ELECTRONIC VALVE SPECIFICATIONS

SPECIFICATION AD/CV2160
ISSUE NO.4 DATED 13.9.57

AMENDMENT NO. 1

AMENDMENT No. 2

FIG. 1.

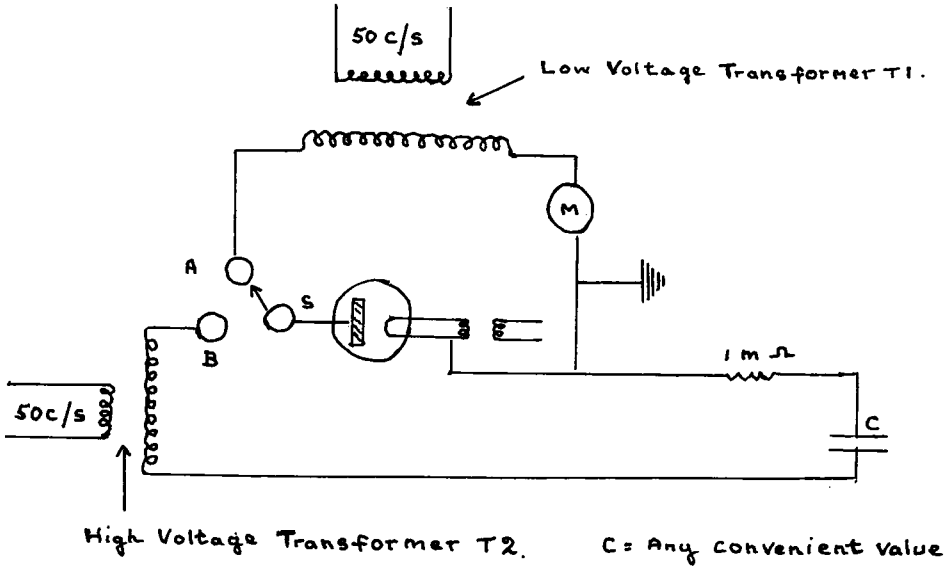
Page 2. Note 4.

Delete last sentence and add following:-

A permissible life test procedure shall be to subject the valve to short periods of operation at the specified mean anode dissipation and negligible inverse anode voltage, alternating with short periods of operation at zero anode dissipation and the maximum rated peak inverse anode voltage. Thus with the circuit shown in Fig. 1, it will be permissible to operate the valve during the test as follows:-

(a) S shall be connected to A for 1 minute with the transformer T1 adjusted to give a mean anode dissipation of about 130 watts.

(b) At the end of 1 min. as in (a), S shall be switched rapidly from A to B and left connected to B for 1 minute with the transformer T2 adjusted to provide a peak inverse anode voltage of 40 kV in the valve.

(c) At the end of the minute as in (b), S shall be switched rapidly from B back to (A), and the operation as in (a) repeated.

The operations (a), (b) and (c) shall be repeated thirty times an hour throughout the period of the test.

During the test there shall be no sign of arc-back or sparking in the valve.
